# PARTS & SERVICE NEWS

REF NO.	<b>AT02127</b>
DATE	<b>Nov. 1, 2002</b>

**SUBJECT:** REPAIR PROCEDURE OF WINDOW MOTOR FAILURE ON WA1200-3

**PURPOSE:** To introduce the modification procedure to repair power window failures on WA1200-3 wheel loaders

Additional working procedure - 1

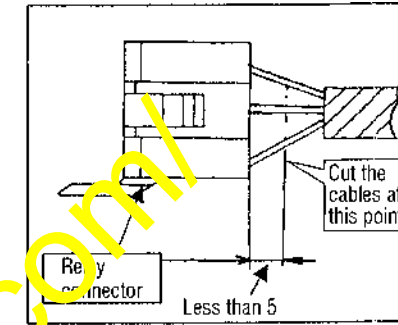
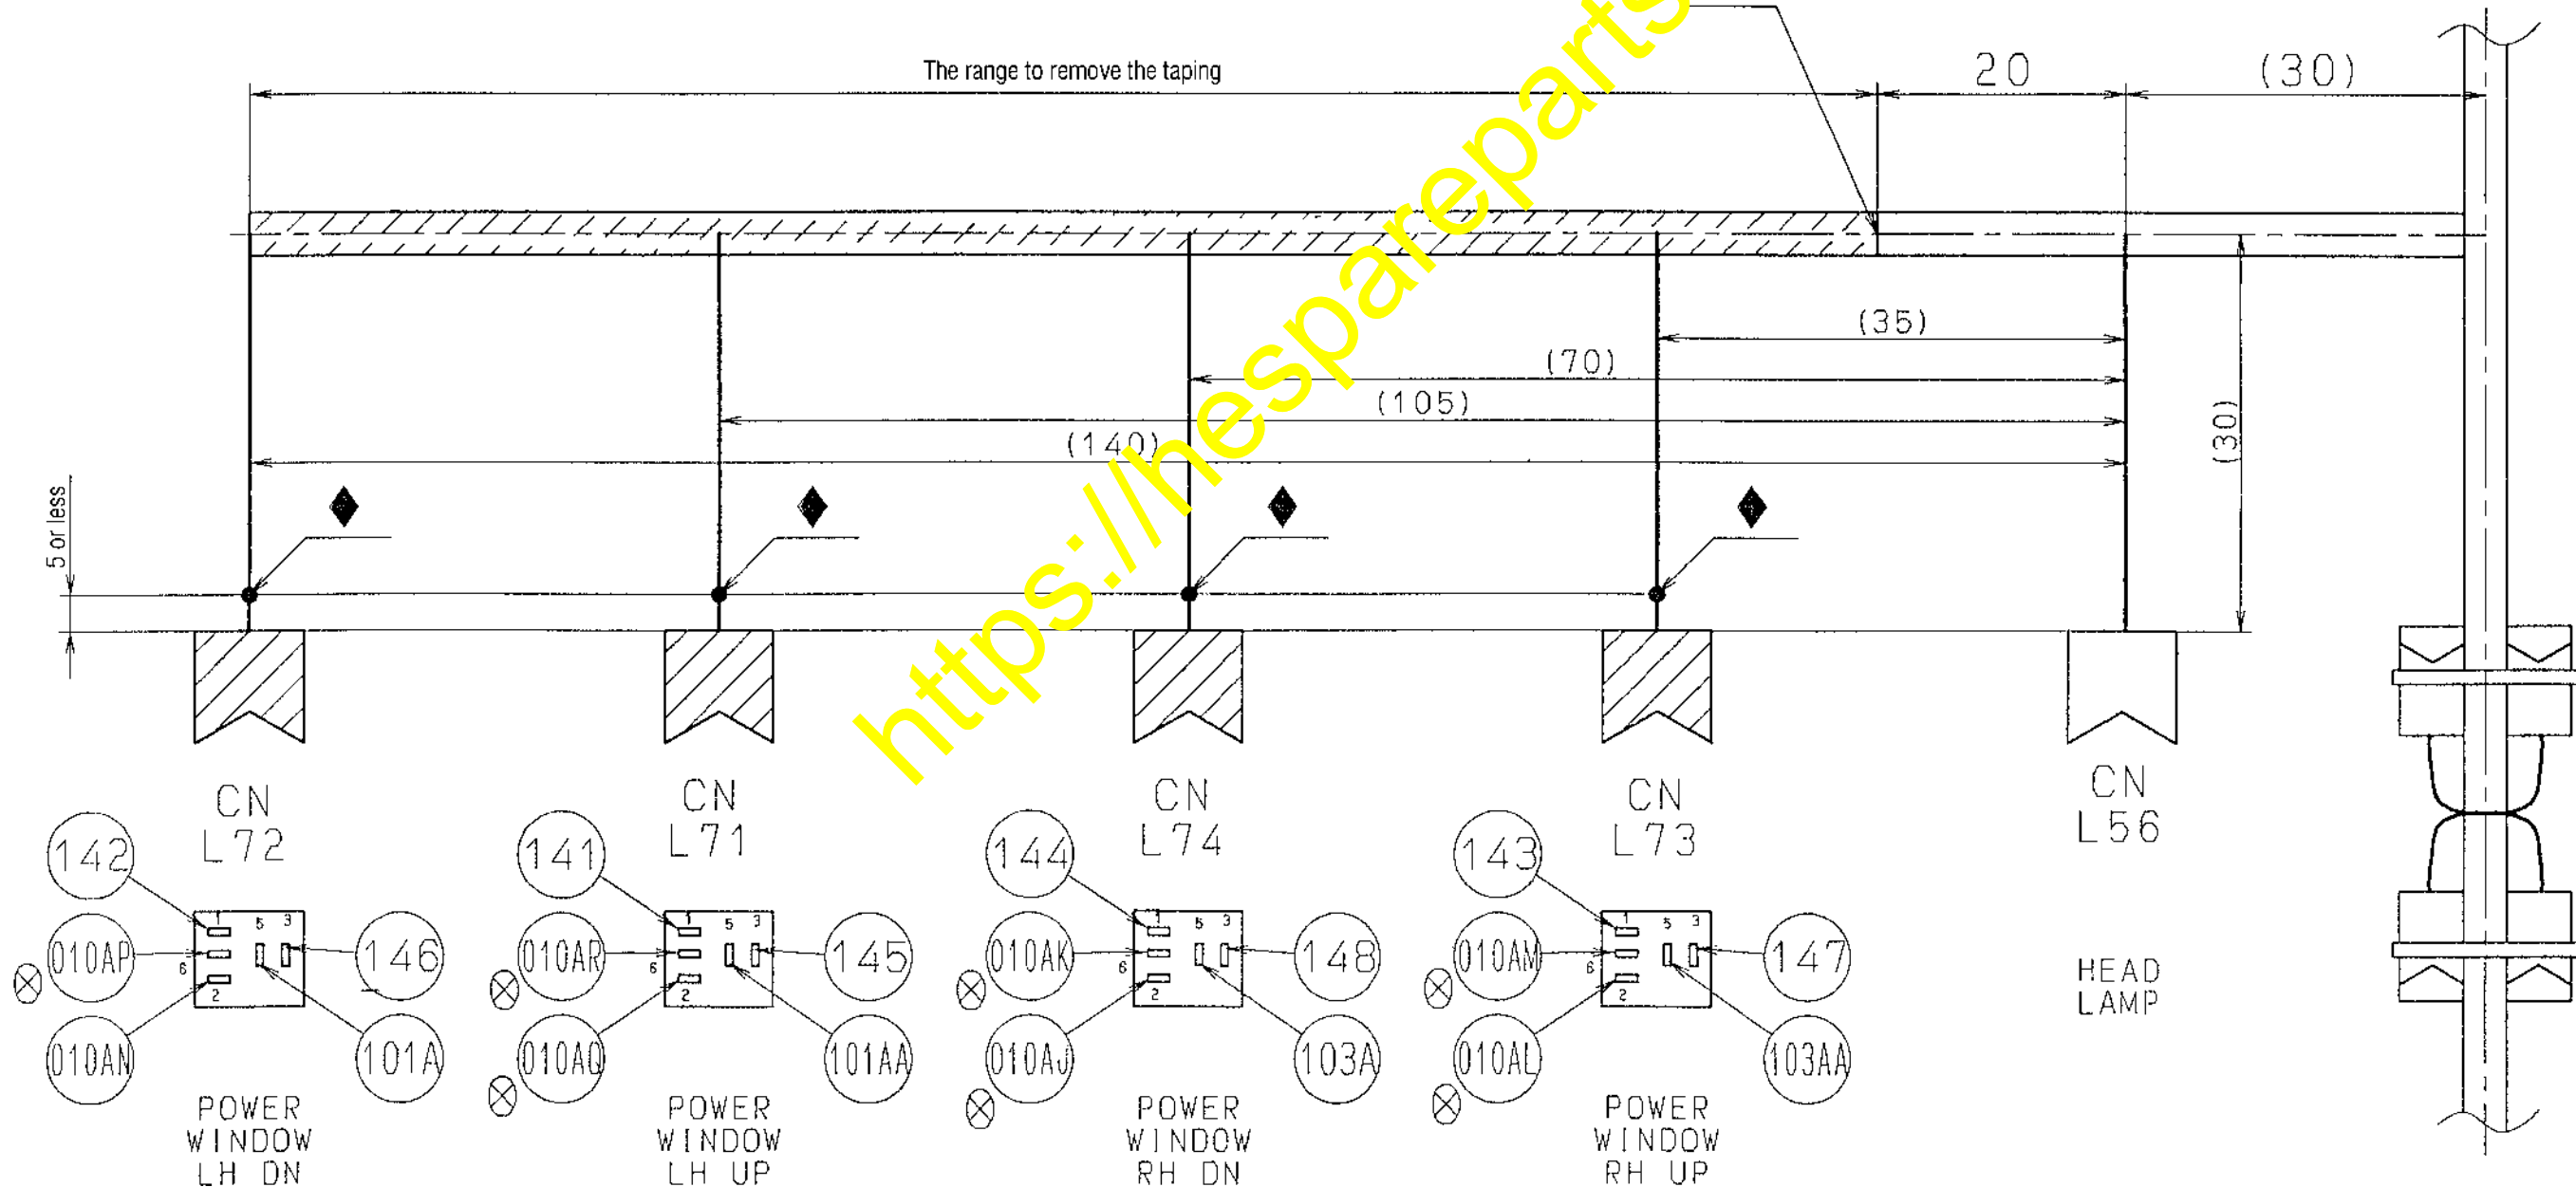
Disassembly and cutting of the floor harness at the power window relay section inside the console box, RH

- Remove the tape being wound around the  marked section in the drawing below up to the  marked position taking care not to break the tape midway. Regarding the cables connecting to the connectors CN L71, CN L72, CN L73 and CN L7 write the cable numbers on the respective tapes of the 13 cables excluding the 7  marked cables in the drawing shown below.
- Cut all the 20 cables at the 4 places marked  in the drawing shown below. Use of the hatched connectors with the current connector numbers CN L71, CN L72, CN L73 and CN L7 at 4 places will be canceled.

Note: Since same color cables exist, put a tape indicating the cut section (for example: L72) onto the cable to clarify the cut section.

Note: This cutting length matches to the connection to the new connector (L71R).

Additional working procedure - 2

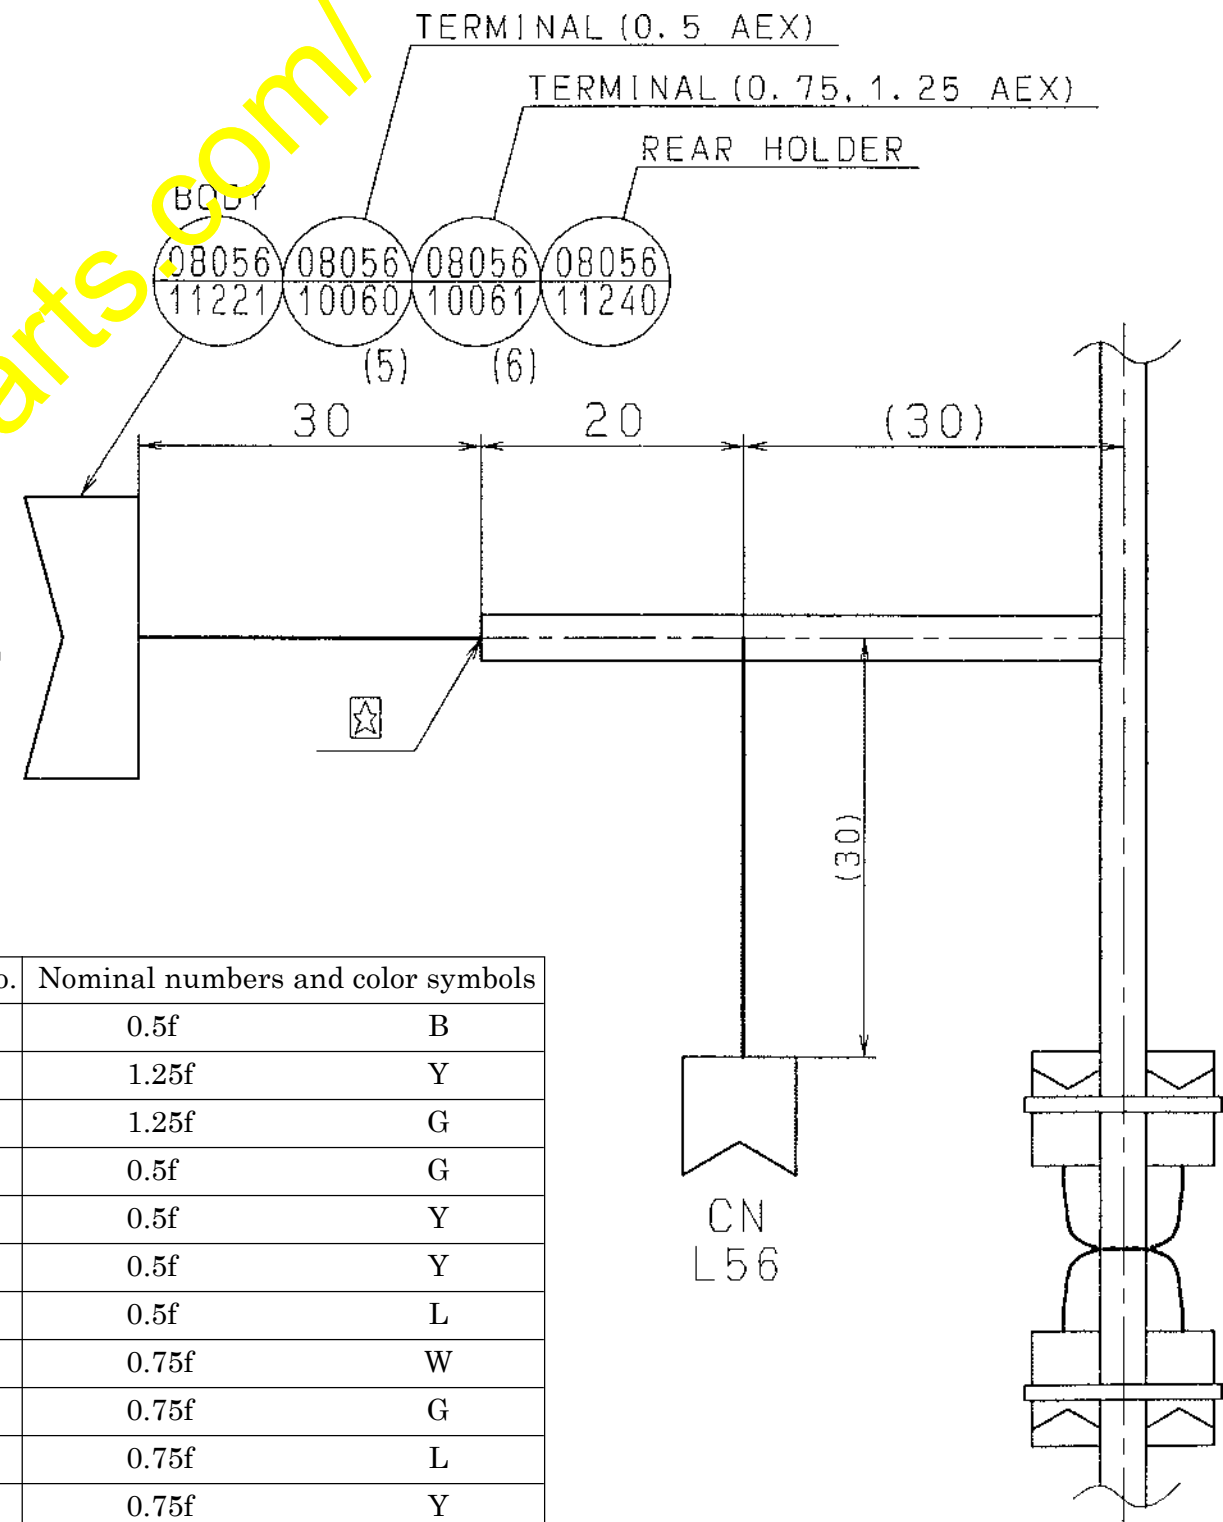
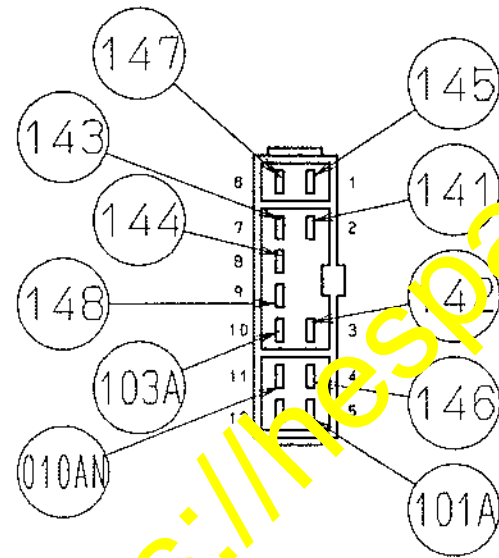
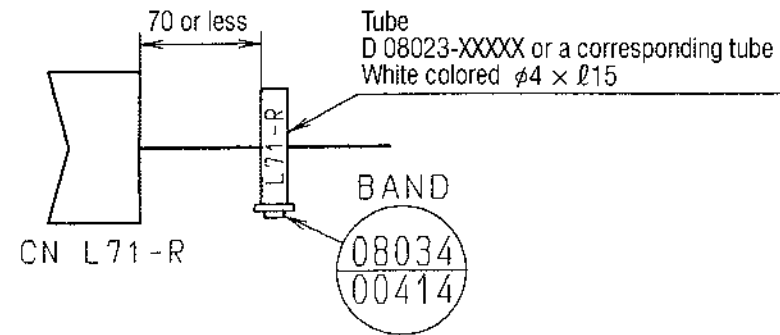
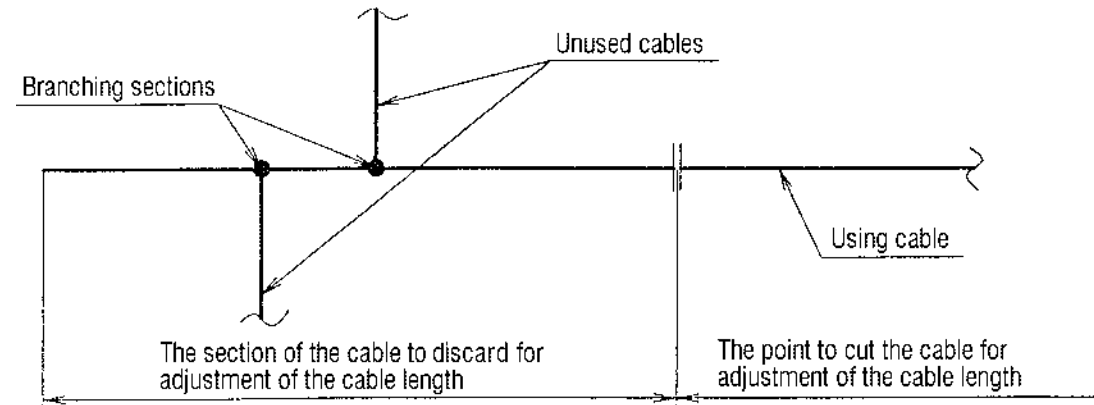
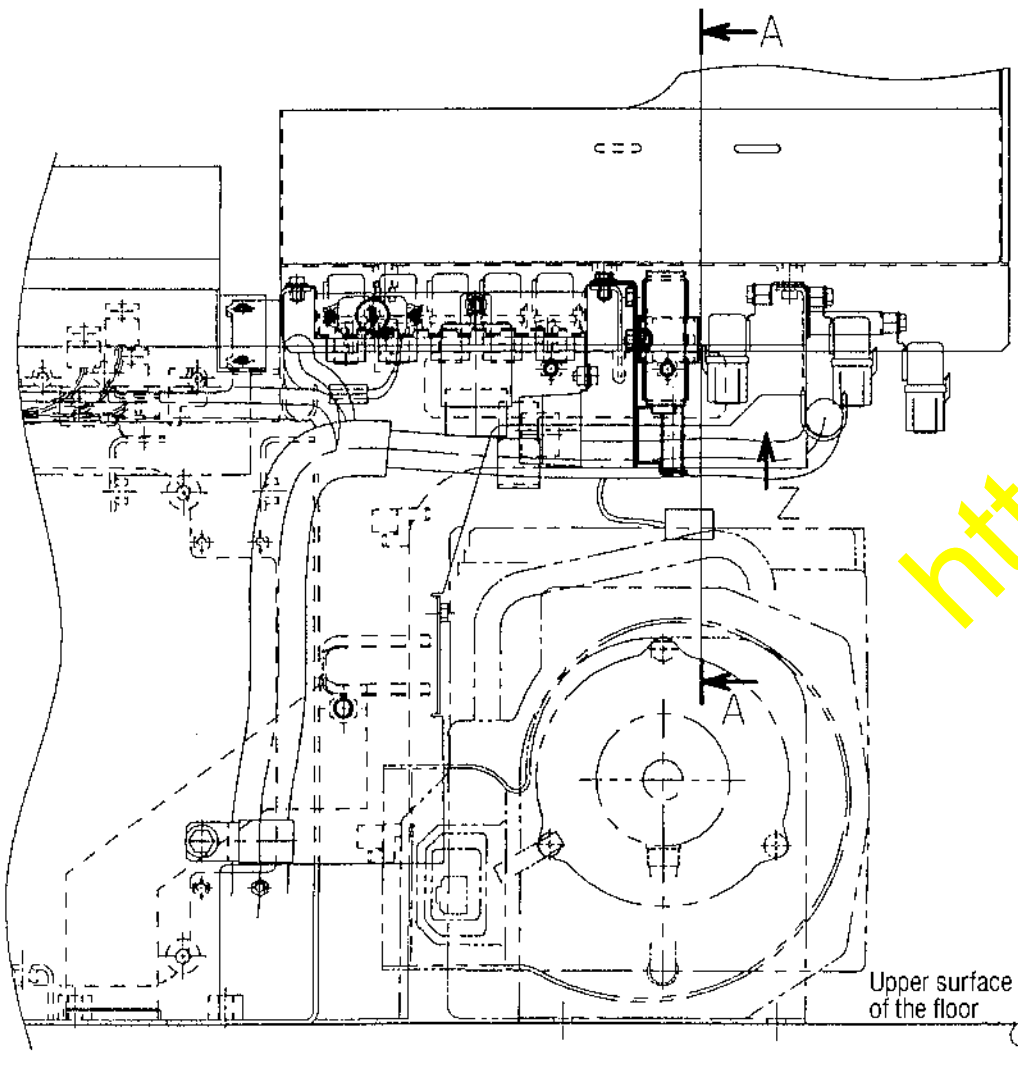
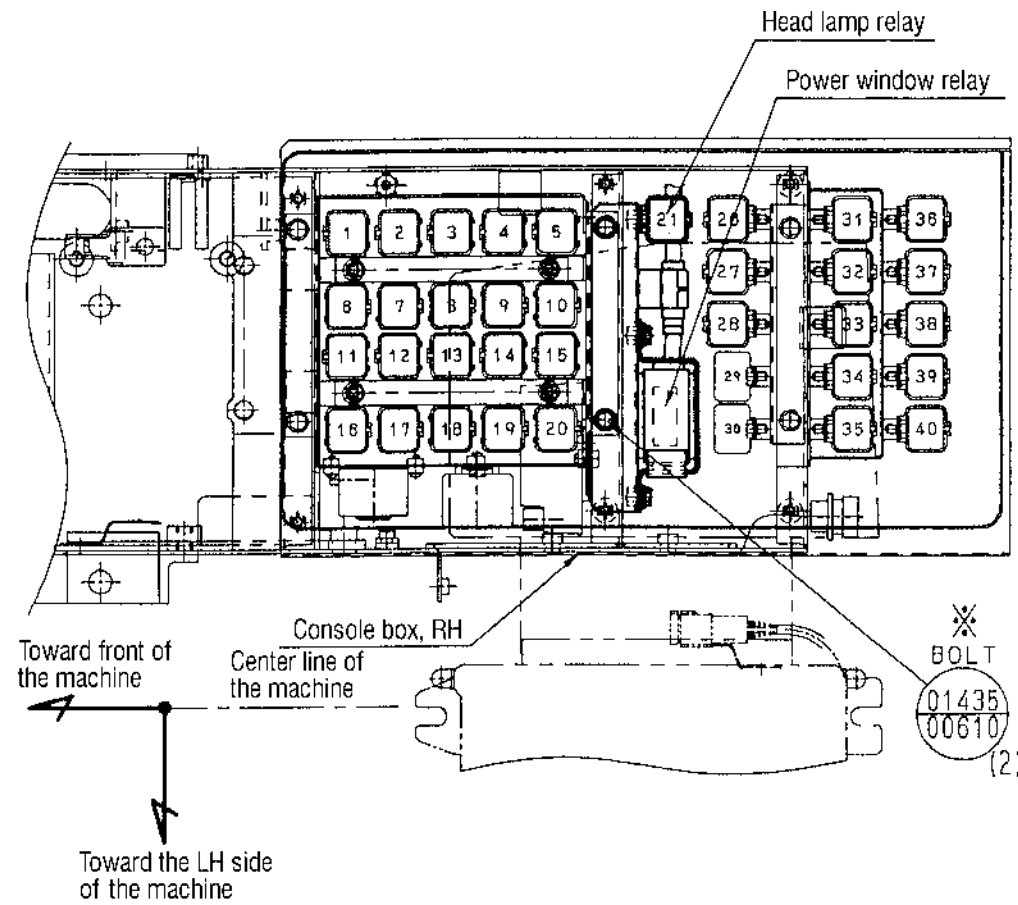
Reconnection to the floor harness after the disassembly and cutting work

- After confirming the cable to connect to the newly prepared connector CN L71-R and after adjusting the length of each cable to the lengths being indicated in the drawing, remove the insulating cover at their edges by 4 to 5 mm and crimp the terminal before inserting into the connector. (Since there can be cases where the crimping is imperfect, solder them after finishing the crimping work.)

- Regarding the power cables No. 101AA (0.75fY) and 103AA (0.75fG) which are not being used after this modification, cut them at their branching sections, or cut them at the  marked sections with 20 mm or more of allowances and insulate them by taping. Regarding other 7 grounding cables, cut them after arranging their ends even and gather them up by taping. (Part No. of the using tape: KES D08024-91920 or equivalent tape)

- Finish the end section of the  marked taping securely so that oil, dust, etc. may not adhere to the end section of the taping. Taping at the end should be of the triple winding and cut the remaining section of the tape. (The tape which has been removed as per the instructions given on page 6 may be reused.)

- Regarding the connectors, write the connector number as shown in the drawing below.

Note: In cases like being indicated in the drawing below, cut and discard the section including the branching sections and, although it will be the matter of course, taping work is not necessary for these unused cables.

Installation procedure

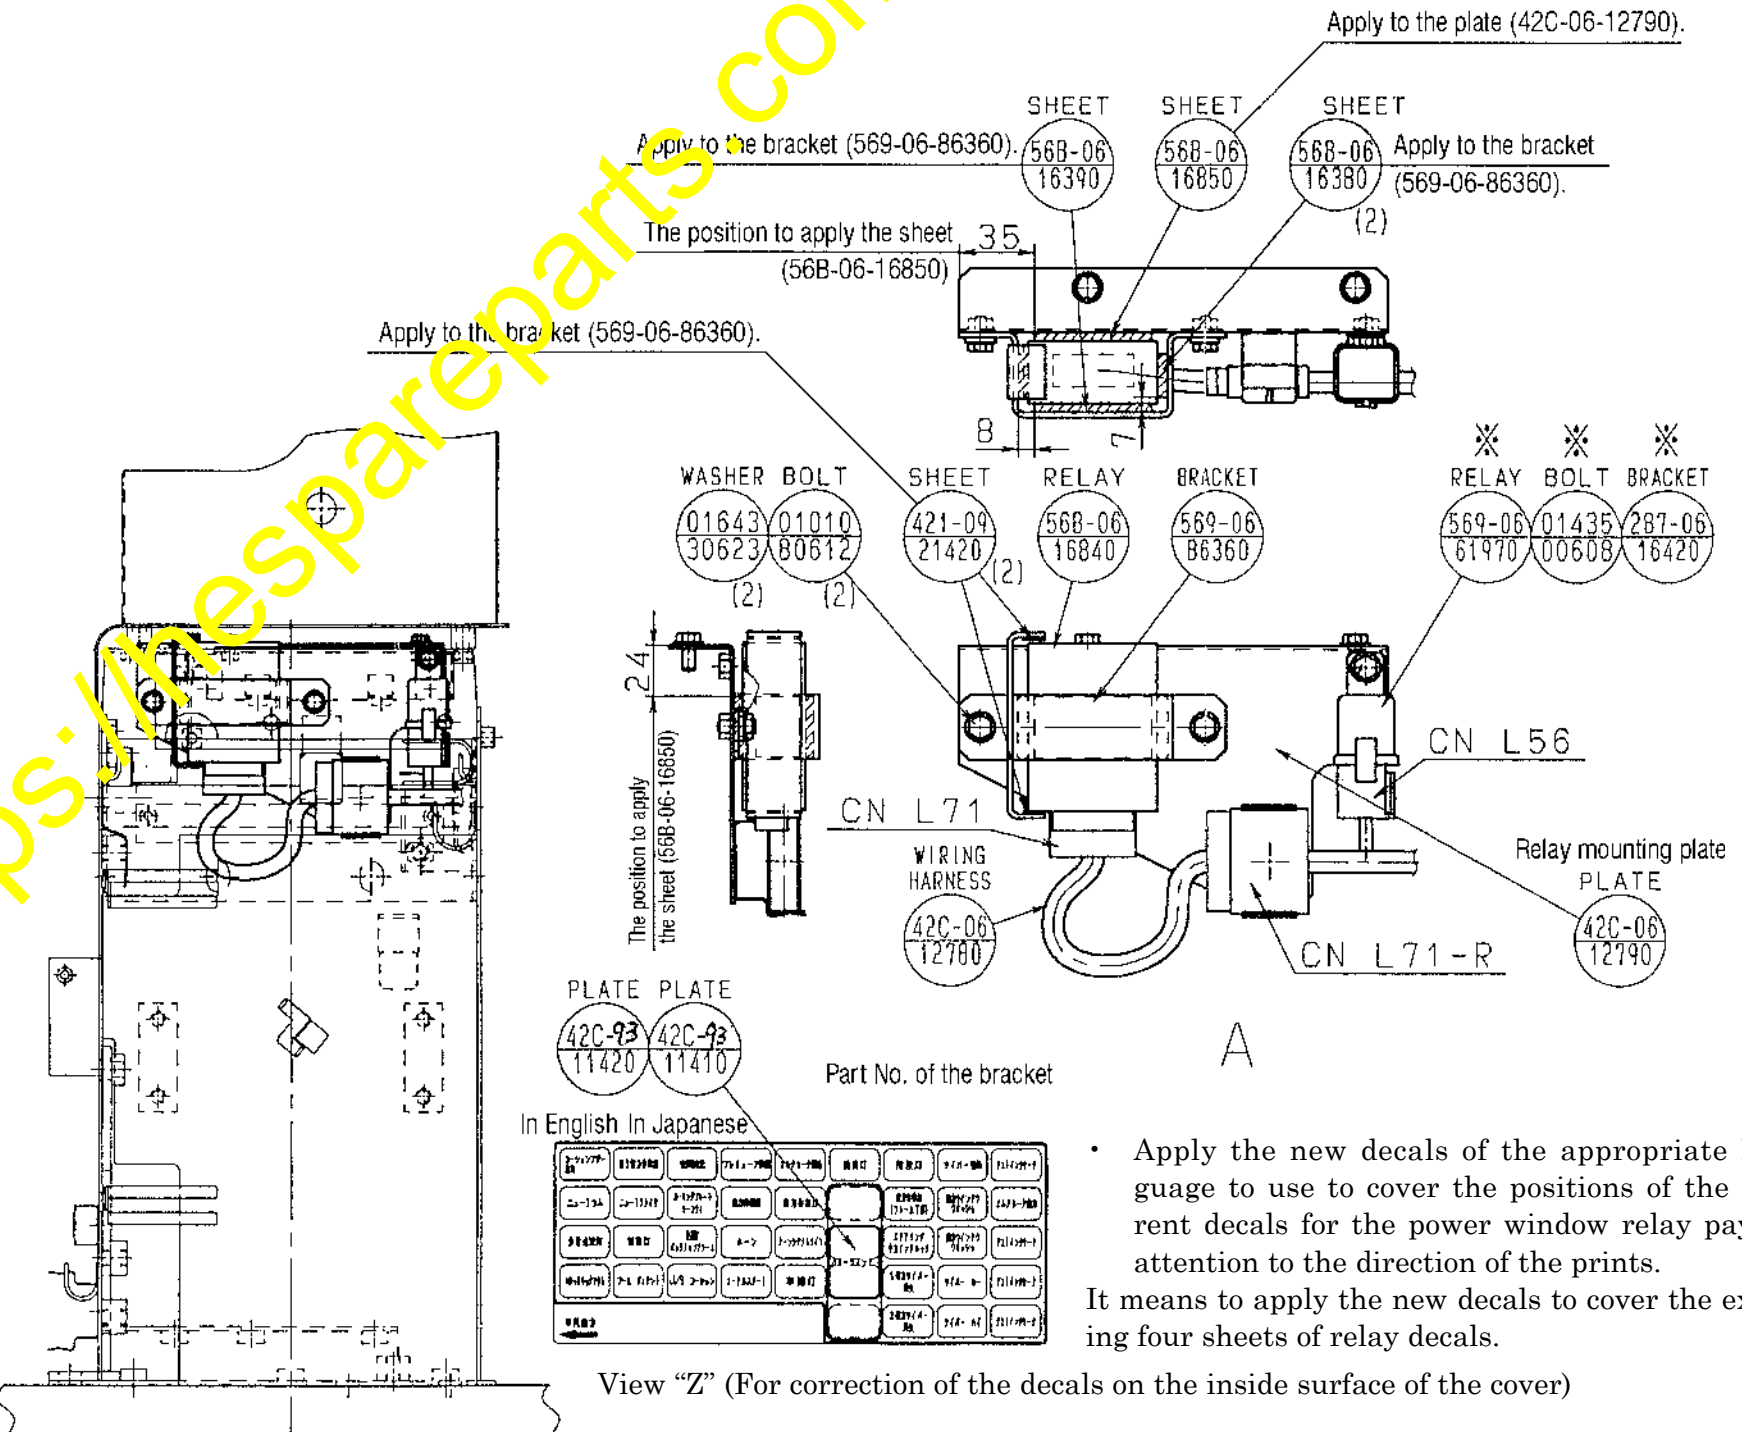
Installation and wiring of the power window relay

- Regarding the parts marked ※, reuse the existing parts which have been removed as per the instructions on page 7.
  - Apply the sheet (56B-06-16850) to the relay mounting plate (42C-06-12790) and apply the sheets (56B-06-16390), (56B-06-16380: 2 sheets) and (421-09-21420: 2 sheets) to the relay mounting bracket (569-06-86360) at the positions instructed in the drawing below.
  - Connect the connectors L56, L71R and L71 of the wiring harness and connect the power window relay and the existing head lamp relay. (Tightening torque for the M6 bolts should be at 8.8 – 14.7 Nm {0.9 – 1.5 kgm})
  - After checking the operation of the power window, reinstall the cover which has been removed as per the instructions on page 7 after correcting its decal (Refer to the View "Z".)
- "Tightening torque for the 4 pcs. of the cover mounting screws (※421-09-21430): 3.43 – 4.41 Nm {0.35 – 0.45 kgm}"

- Apply the new decals of the appropriate language to use to cover the positions of the current decals for the power window relay paying attention to the direction of the prints. It means to apply the new decals to cover the existing four sheets of relay decals.
